Co3237 Poultney BF 0145(13)

ADDENDUM #1

- Invitation for Bids, and Proposal to extend Bid Opening to June 13, 2025, and update the Schedule of Items.
- Special Provision Pages 1 and 6.
- Plan sheets 3, 10, 11, 44-52, 57, 63, 65, 79-82, 93, 94, 96, and 97.
- New Impact Plans shall replace Pages 136 to 171 in the Proposal.

POULTNEY RIVER CROSS SECTIONS
STA. 10+80 - 11+00
SCALE 1" = 10'-0"

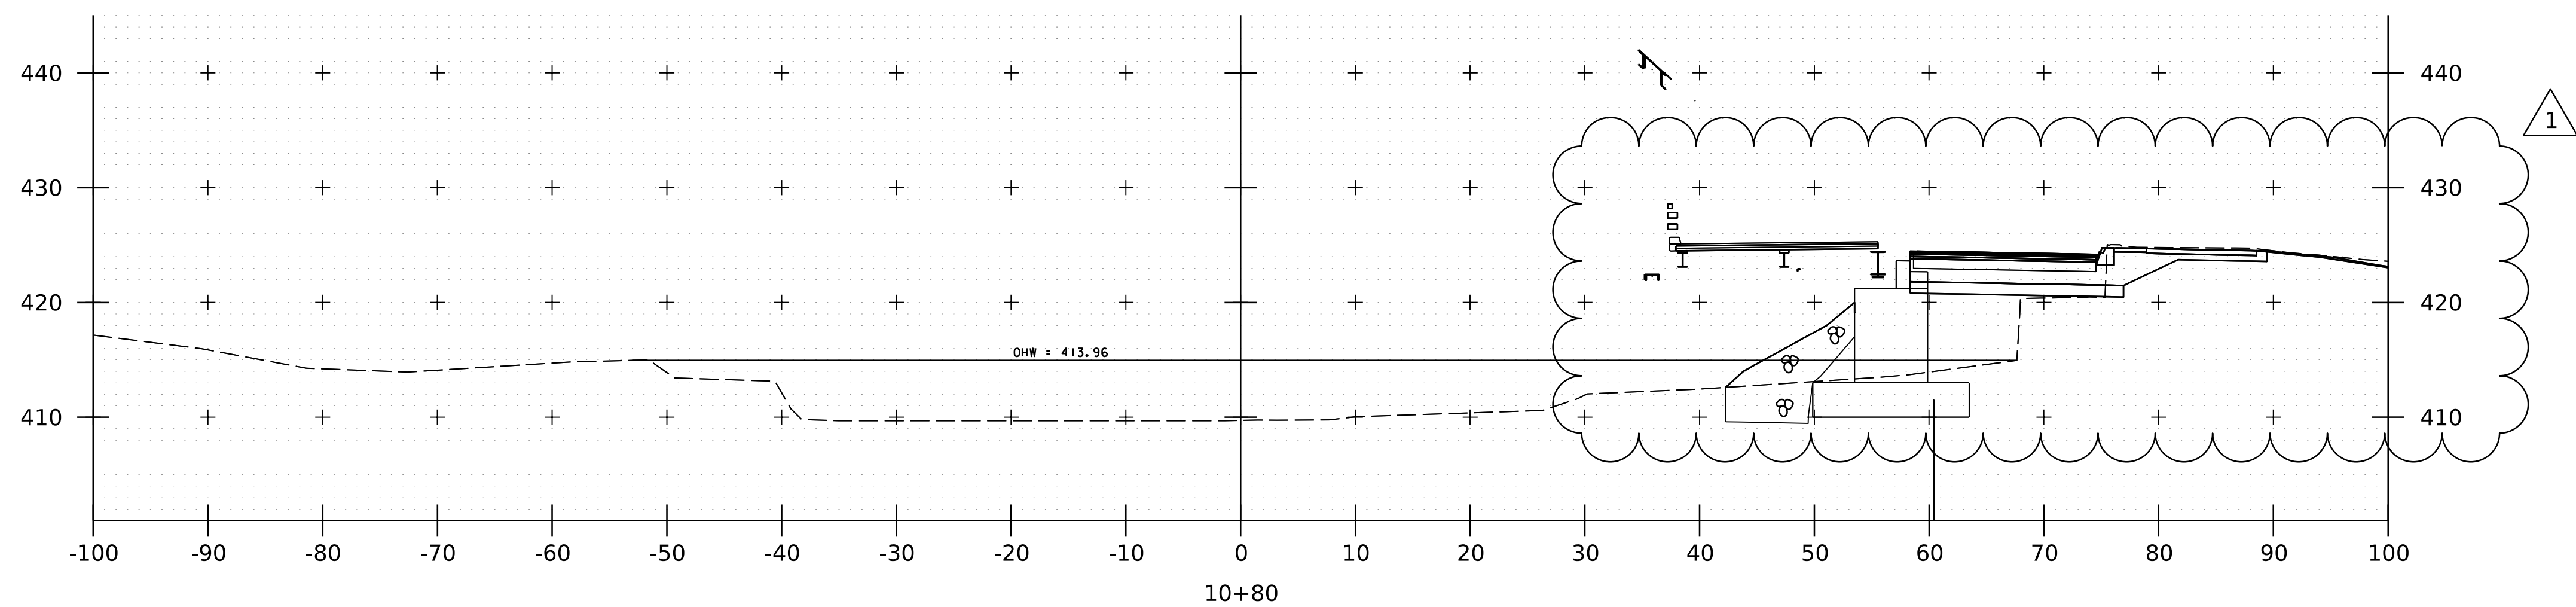
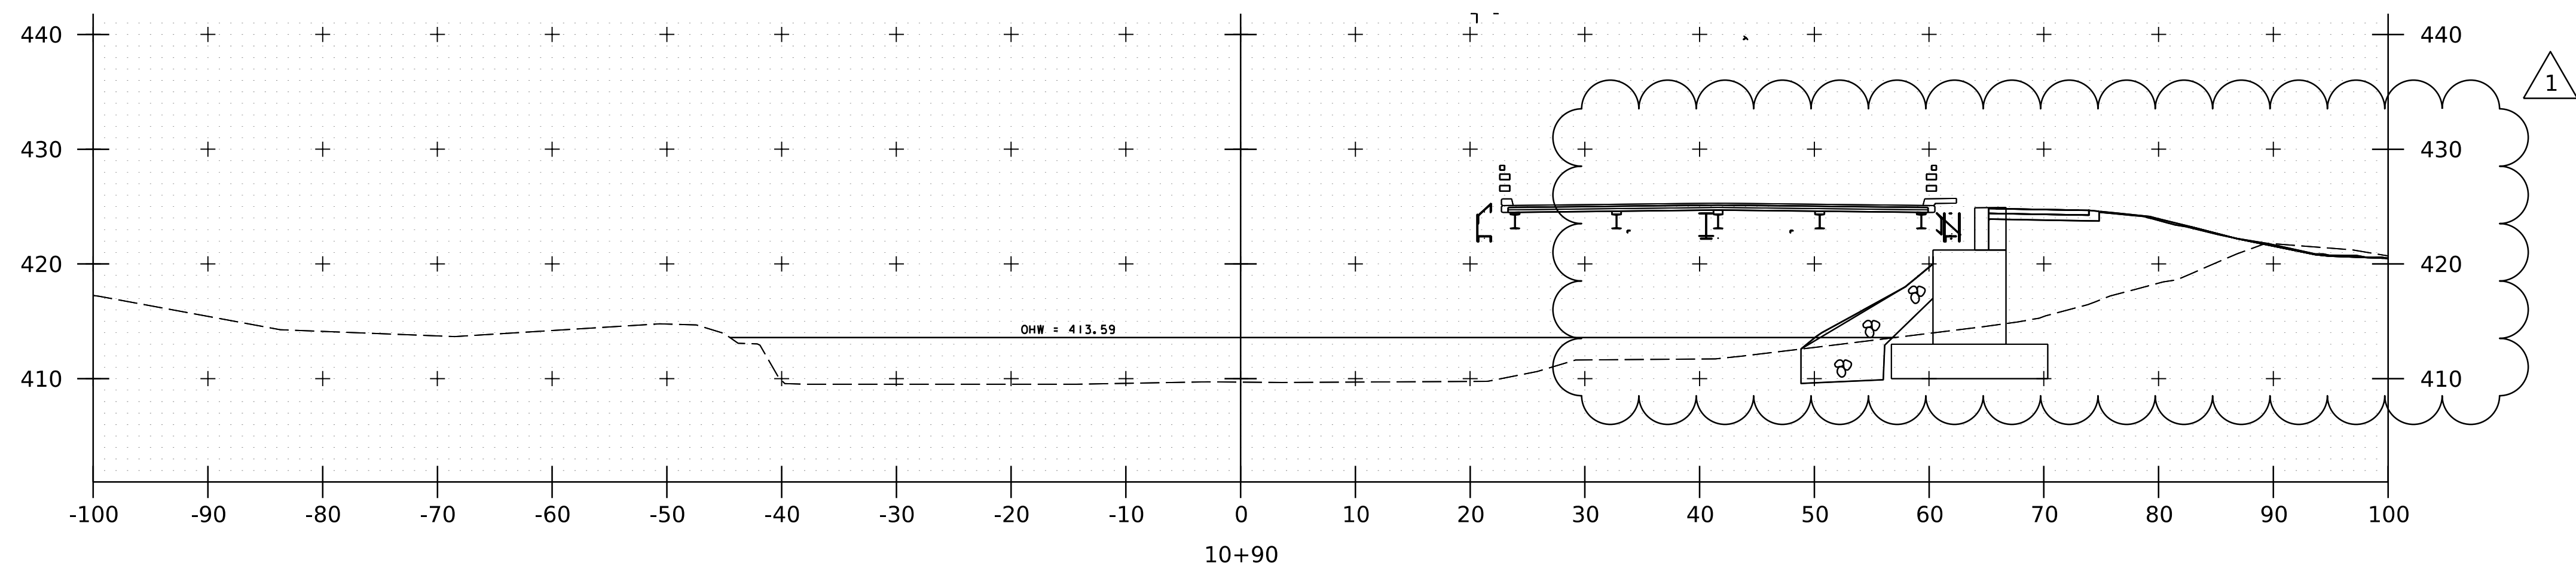
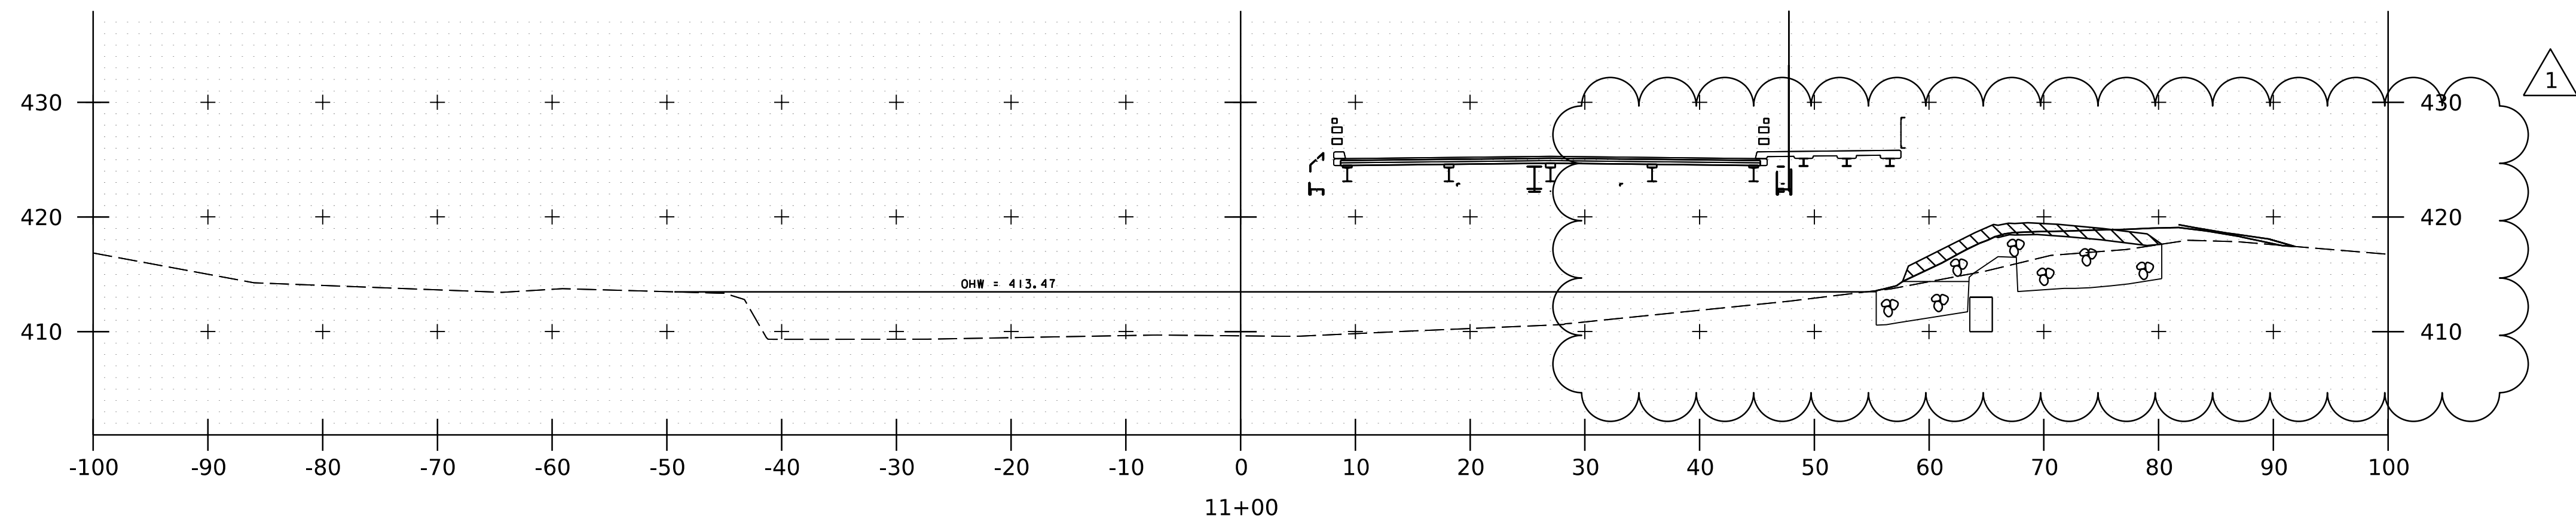
ADDENDUM	REVISION	PLOT DATE	DESCRIPTION	BY
1	1	19-MAY-2025	UPDATED FOR CURRENT ABUTMENT MODEL	MSWT
PROJECT NAME: POULTNEY				
PROJECT NUMBER: BF 0145(I3)				
FILE NAME: z2lj64xs_channel.dgn			PLOT DATE: 19-MAY-2025	
PROJECT LEADER: J.D. KEENER			DRAWN BY: T.D. BURT	
DESIGNED BY: N.A. TRUSLOW			CHECKED BY: J.D. KEENER	
CHANNEL CROSS SECTIONS SHEET (3 OF 8)			SHEET 94 OF 115

POULTNEY RIVER CROSS SECTIONS
STA. 11+40 - 11+50
SCALE 1" = 10' - 0"

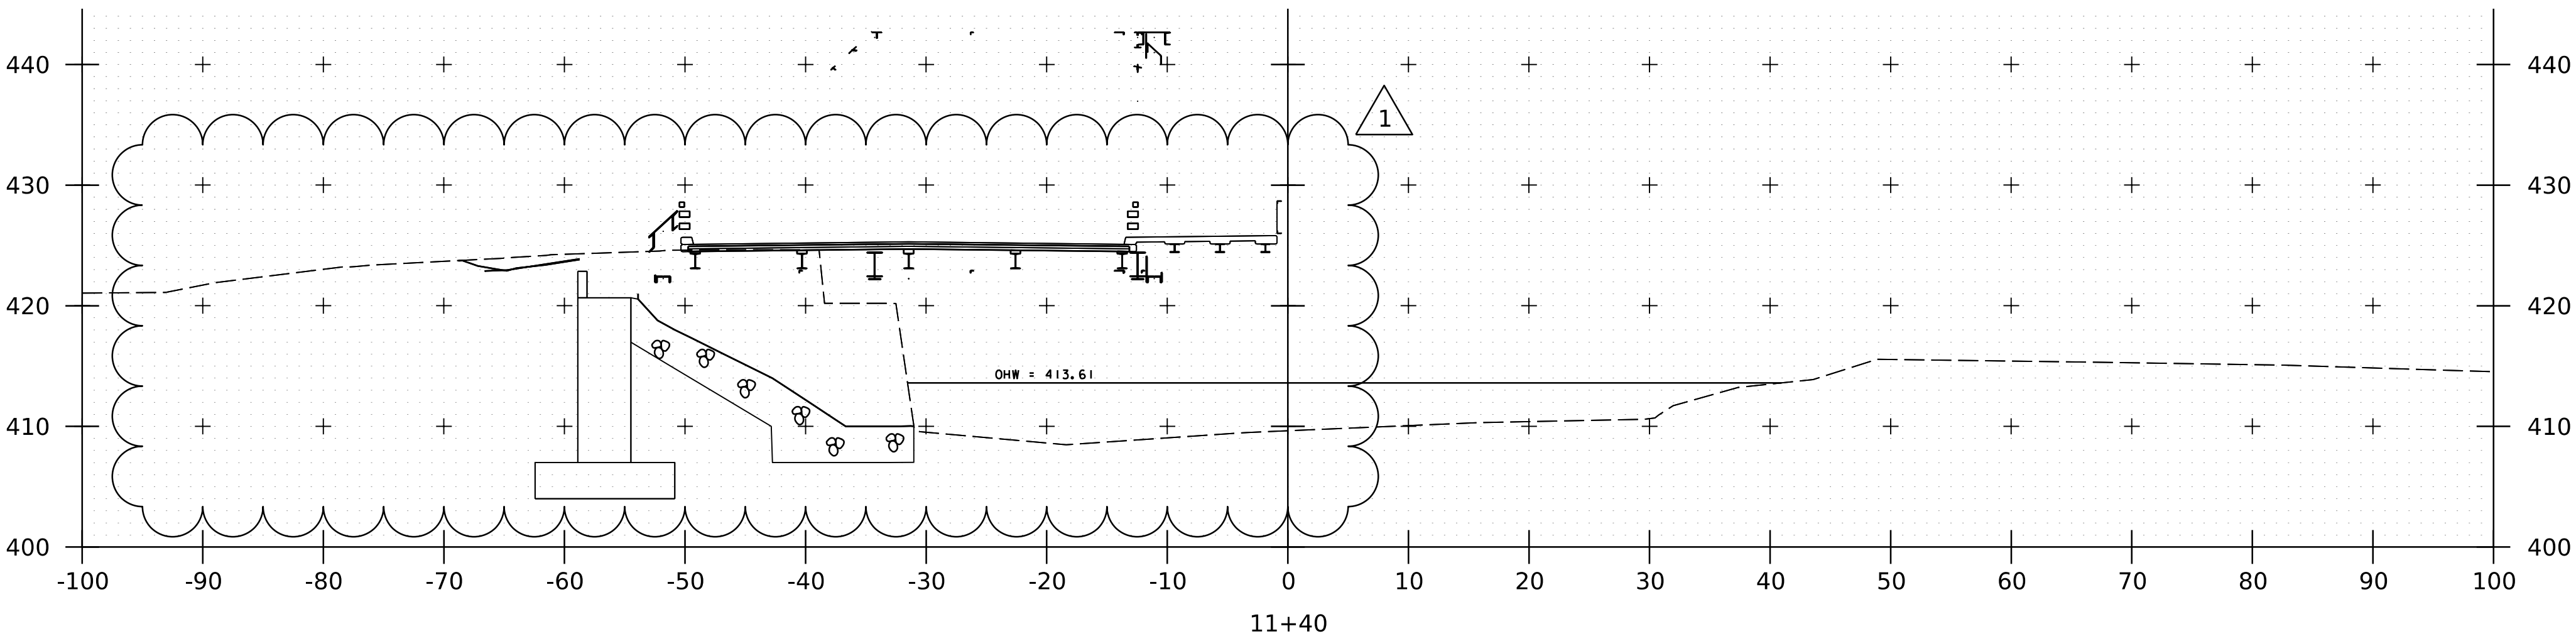
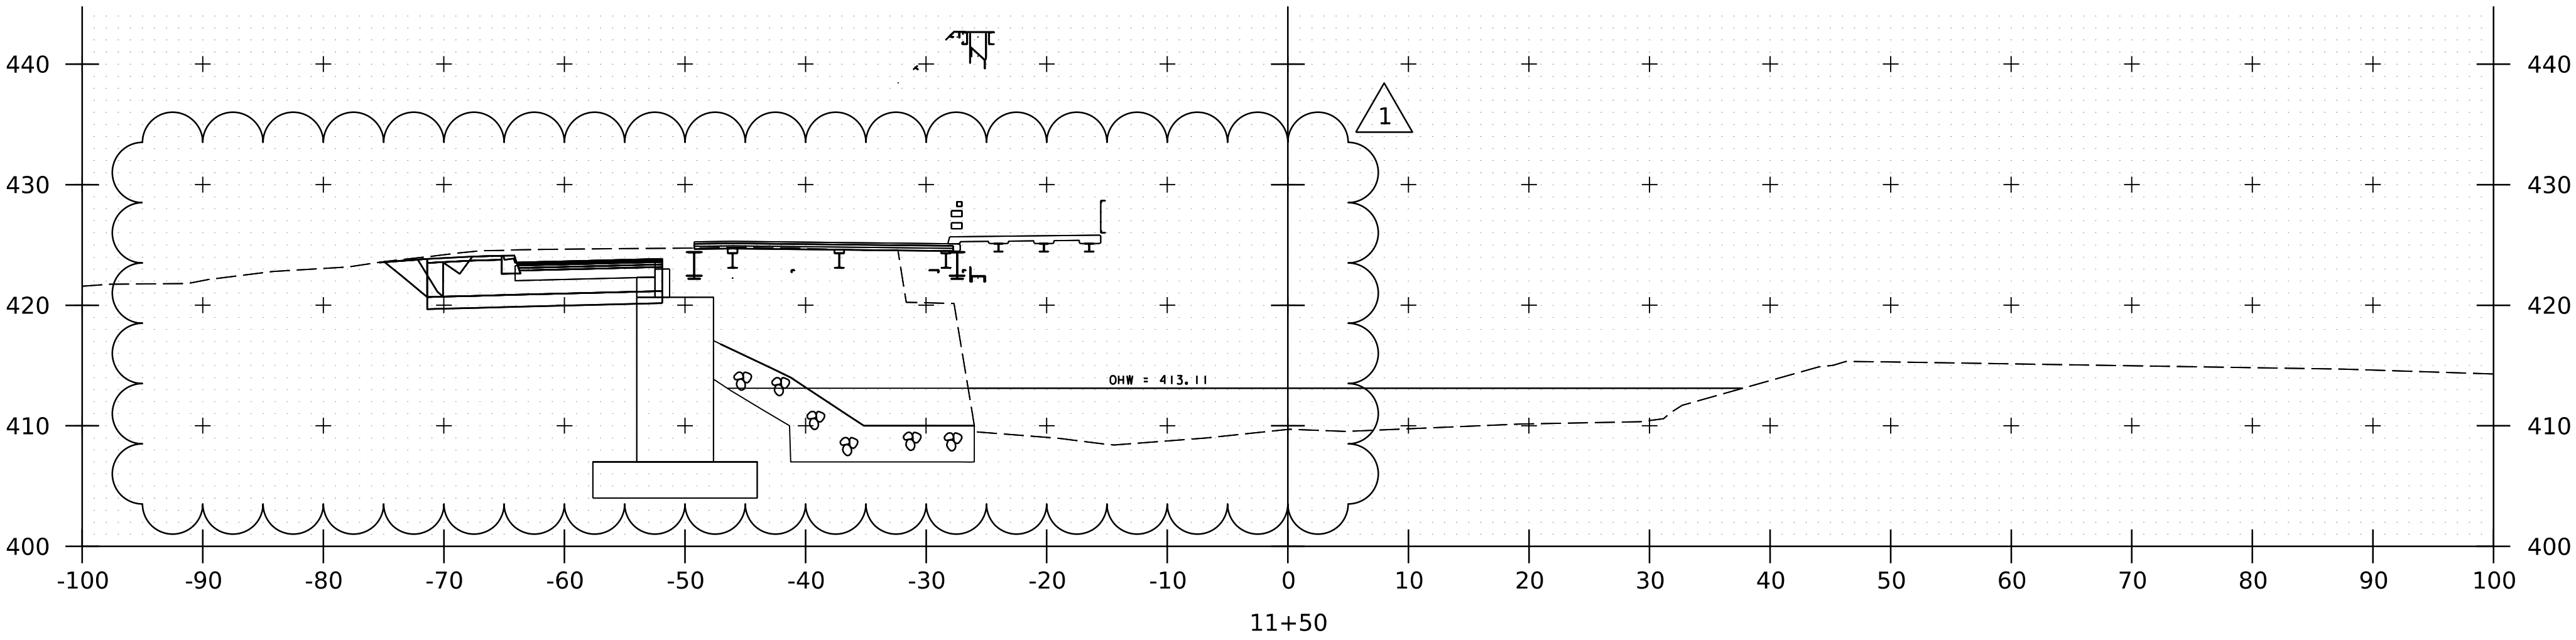
ADDENDUM	REVISION	PLOT DATE	DESCRIPTION	BY
1	1	19-MAY-2025	UPDATED FOR CURRENT ABUTMENT MODEL	MSWT
PROJECT NAME: POULTNEY				
PROJECT NUMBER: BF 0145(13)				
FILE NAME: z2lj64xs_channel.dgn			PLOT DATE: 19-MAY-2025	
PROJECT LEADER: J.D. KEENER			DRAWN BY: T.D. BURT	
DESIGNED BY: N.A. TRUSLOW			CHECKED BY: J.D. KEENER	
CHANNEL CROSS SECTIONS SHEET (5 OF 8)			SHEET 96 OF 115

POULTNEY RIVER CROSS SECTIONS

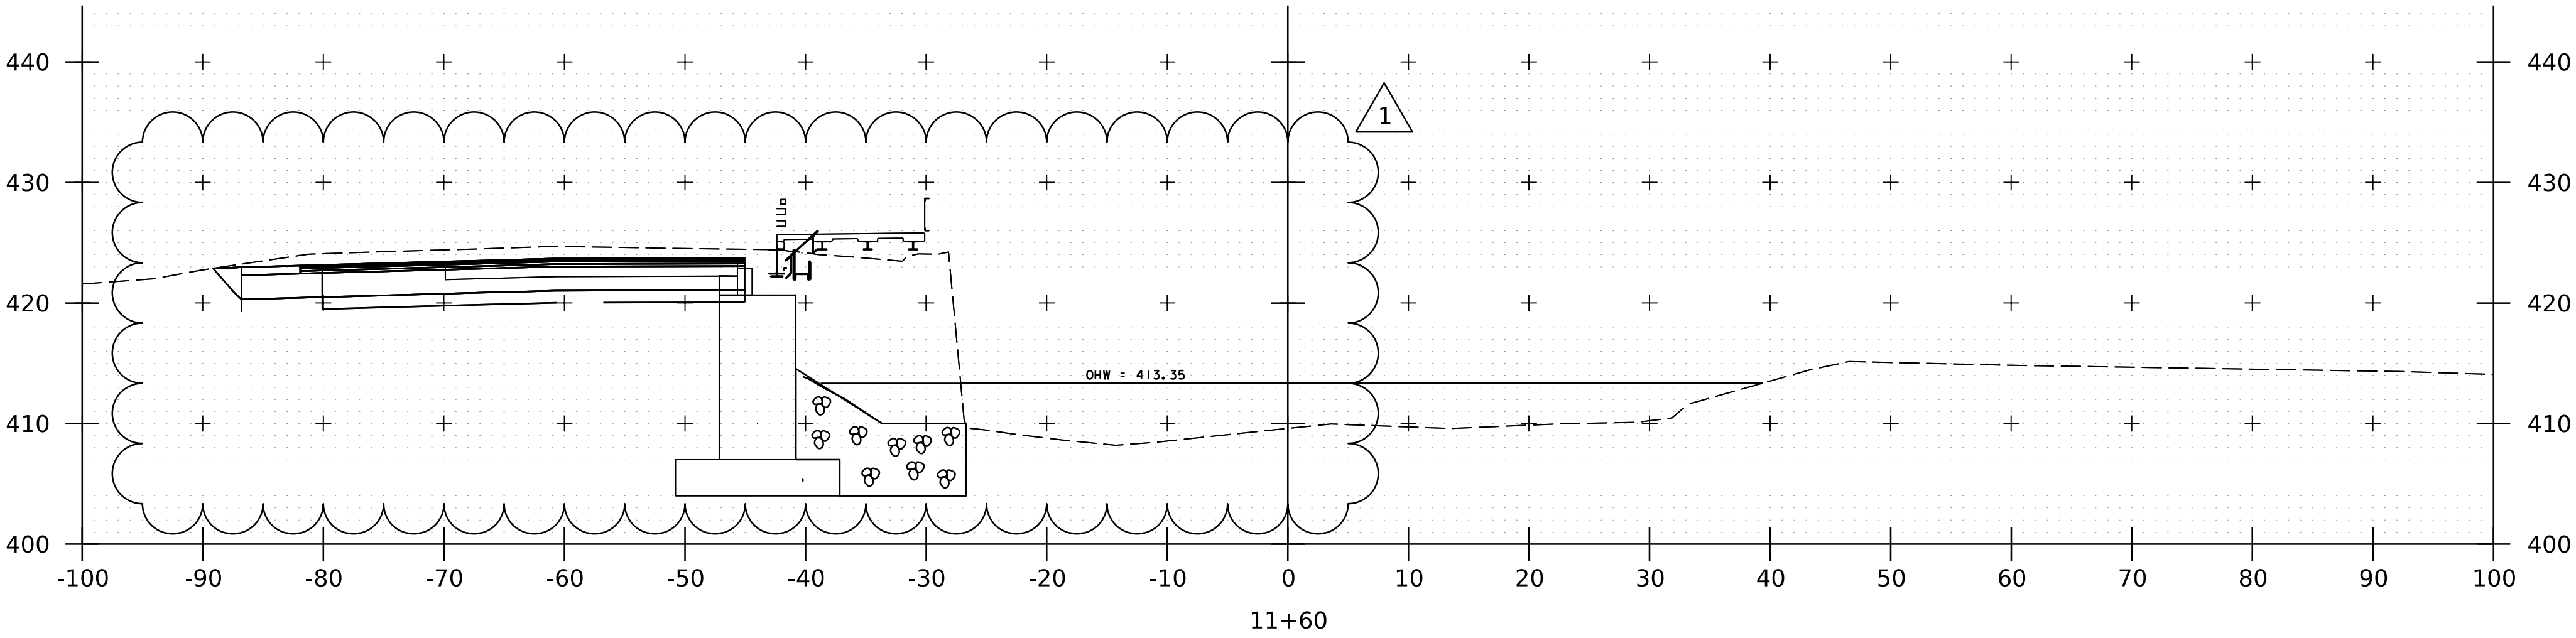
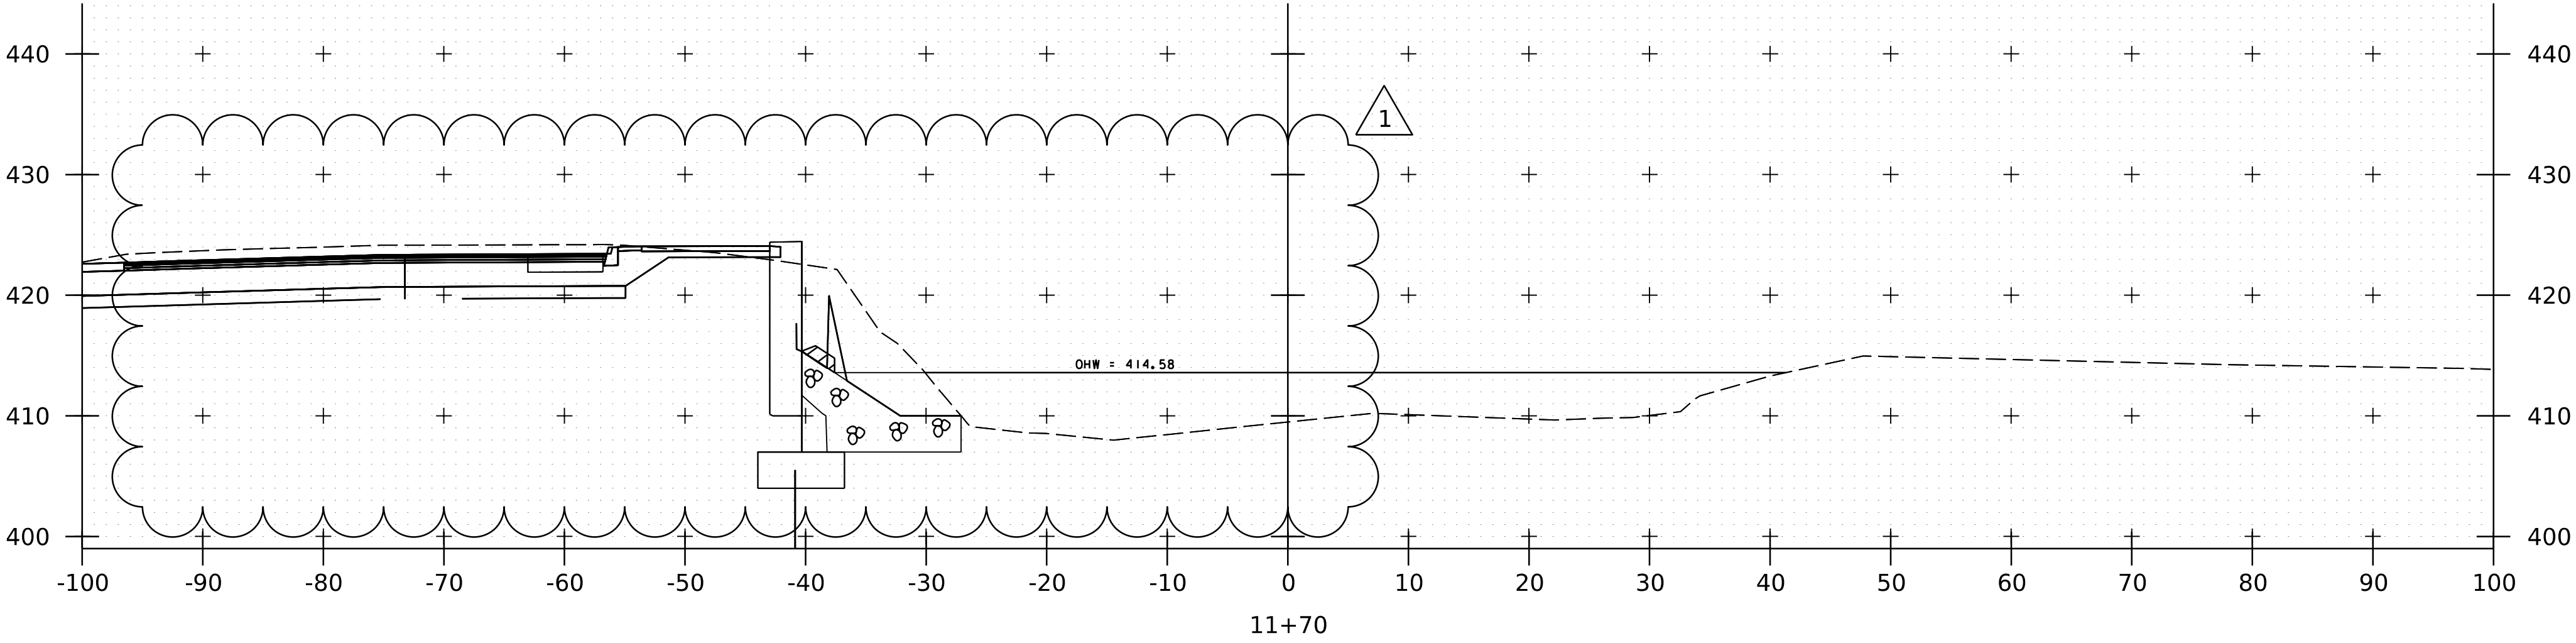
ADDENDUM	REVISION	PLOT DATE	DESCRIPTION	BY
1	1	19-MAY-2025	UPDATED FOR CURRENT ABUTMENT MODEL	MSWT
PROJECT NAME: POULTNEY				
PROJECT NUMBER: BF 0145(13)				
FILE NAME: z2lj64xs_channel.dgn			PLOT DATE: 19-MAY-2025	
PROJECT LEADER: J.D. KEENER			DRAWN BY: T.D. BURT	
DESIGNED BY: N.A. TRUSLOW			CHECKED BY: J.D. KEENER	
CHANNEL CROSS SECTIONS SHEET (6 OF 8)			SHEET 97 OF 115
